TSIB 22-13 Rev A		December 19, 2022
<b>TO:</b>	Affected Operators	
<b>TITLE:</b>	Torque value changes to splined joints in the steering system.	
<b>APPLICABILITY:</b>	New Flyer Xcelsior buses equipped with double tilt steering columns.

This TSIB will provide an updated recommendation for torque of hardware used to secure the splined joints in the steering system between the steering column and the gearbox.

Figure 1: Locations to Torque on Steering System

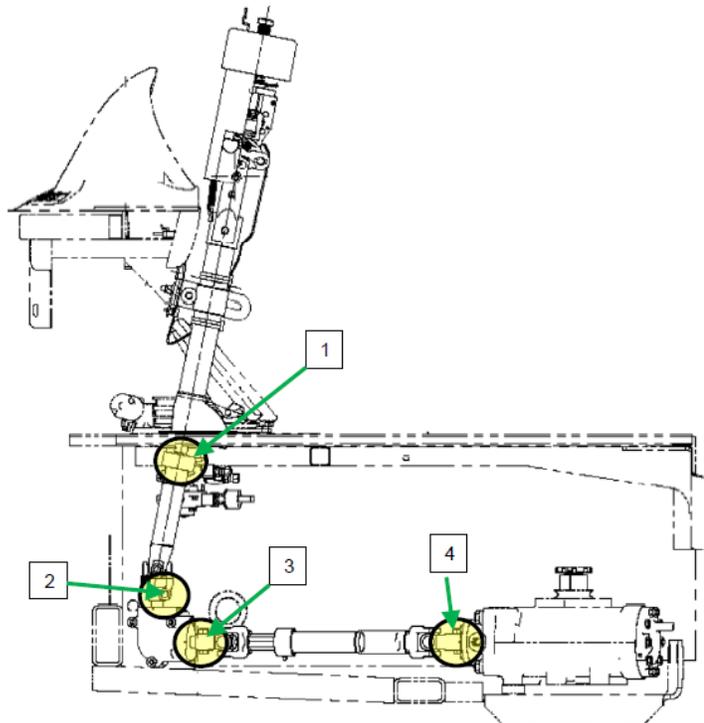
For customers operating New Flyer Xcelsior buses equipped with double tilt steering columns, it is New Flyer’s recommendation that, at the next maintenance interval, the torque in the four locations depicted in the diagram be increased from 50 ft-lb to 70 ft-lb ± 4 ft-lb.
